THE CITY OF SAN DIEGO

MEMORANDUM

SUBJECT: New Standard Drawing for Micro Trench Backfill and Updated Standard Drawing for Narrow Trench Resurfacing

DRAWING
NUMBER **SDG-165**

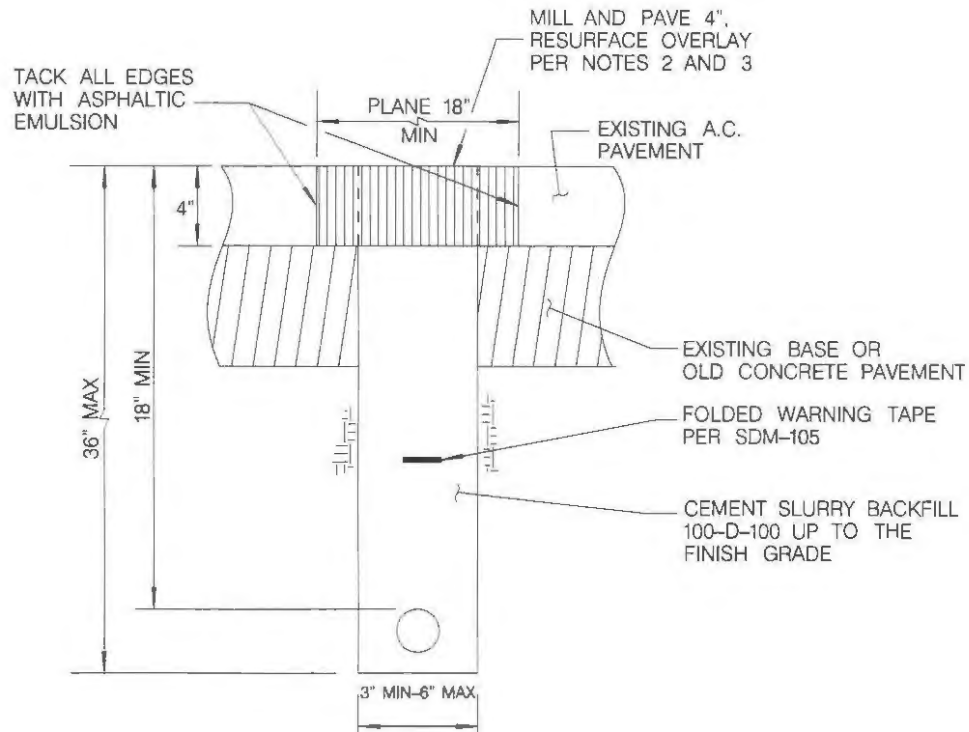
The standard drawing SDG-165 applies to new dry utilities installation using the micro trenching method of construction as described in the attached SDG-165. The standard drawing SDG-117 is an updated drawing, and replaces the existing standard drawing in the Standard Drawings for Public Works Construction 2016 Edition.

1. PAVEMENT CUTS SHALL BE STRAIGHT AND CLEAN. SPALLS AND POTHOLES WITHIN 12 INCHES OF THE MICRO-TRENCH SHALL BE REPAIRED PRIOR TO TRENCHING TO FACILITATE STRAIGHT PAVEMENT CUTS.

2. INSTALL 1 INCH WIDE (FOLDED) WARNING/IDENTIFICATION TAPE PER SDM-105.
3. TRENCH LOCATION SHALL BE AT EDGE OF CURB AND GUTTER. NO MICRO-TRENCHES ALONG MEDIAN CURBS SHALL BE ALLOWED. THE LOCATION OF MICRO-TRENCH IN RELATION TO THE CURB SHALL NOT DEVIATE ALONG ITS ALIGNMENT UNLESS OTHERWISE APPROVED BY THE CITY.

4. WHERE THERE IS NO EXPOSED OR VISIBLE CONCRETE GUTTER, THE NEW CONDUIT SHALL BE INSTALLED IN A NARROW TRENCH PER SDG-117.
5. FIRST INSTALLED CONDUIT SHALL BE PLACED AT A DEPTH OF 18 INCHES WITHIN THE CONDUIT ZONE. THE CONDUIT ZONE SHALL BE 3 INCHES FROM BOTTOM OF GUTTER THROUGH 18 INCHES FROM LIP OF GUTTER. ADDITIONAL CONDUIT(S) SHALL BE INSTALLED WITHIN CONDUIT ZONE, UNLESS OTHERWISE APPROVED BY THE CITY.

6. ONLY ONE MICRO-TRENCH PER SIDE OF THE STREET IS ALLOWED. IF A MICRO-TRENCH EXISTS AND NO ADDITIONAL CONDUIT CAN BE INSTALLED IN THE SAME TRENCH, THE NEW CONDUIT SHALL BE INSTALLED IN NARROW TRENCH PER SDG-117.

7. AT STREET INTERSECTIONS, CONDUIT SHALL BE INSTALLED IN NARROW TRENCH PER SDG-117 WITH PAVEMENT RESURFACING AND ANY OTHER REQUIREMENTS PER CITY REGULATIONS, OR USE TUNNELING PER CITY STANDARDS.

8. BACKFILL/BEDDING BELOW ASPHALT BASED SEALANT SHALL BE DRY SAND (SE 50 OR BETTER). ONCE PLACED, SAND SHALL BE THOROUGHLY CONSOLIDATED BY FLOODING.
